## **Technical Bulletin**

**September 29, 1997**  
**Chilliwack, British Columbia**

**Attention:** Rebel and Elite Owners with Spring Gear  
**Subject:** Inboard Spring Gear Bolt (AN6-45A)

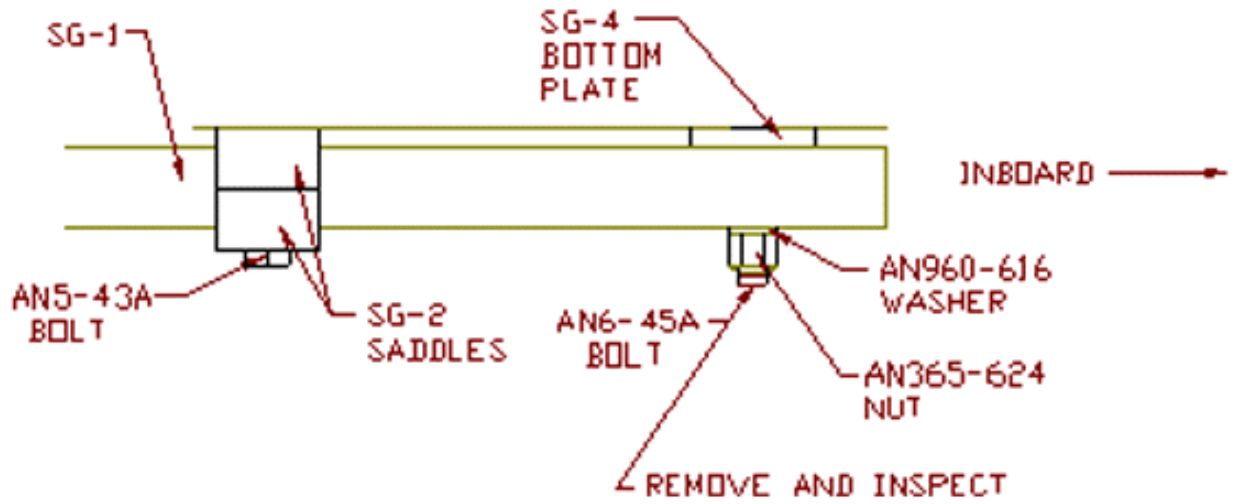
We have been notified by a Rebel customer of an incident involving the failure of the inboard Spring Gear Bolt (AN6-45A) after only 50 hours of service. The customer tells us that the inboard Spring Gear Bolt on one side of the aircraft failed to the breaking point while the inboard Spring Gear Bolt on the other side of the aircraft was found, upon inspection, to have been stretched and bent.

We have received the broken bolt from the customer and we have sent it to a lab for further analysis. We believe this failure to be an isolated case but we would like you to check your inboard Spring Gear bolts for any signs of failure as a precautionary measure. We would appreciate it if you could please inform us of your findings one way or the other. Respond to the above address by phone or fax, or send e-mail to [murtech@murphyair.com](mailto:murtech@murphyair.com).

\* When re-attaching the bolts remember to tighten to the specified torque value of 13 - 16 ft.\*lb.
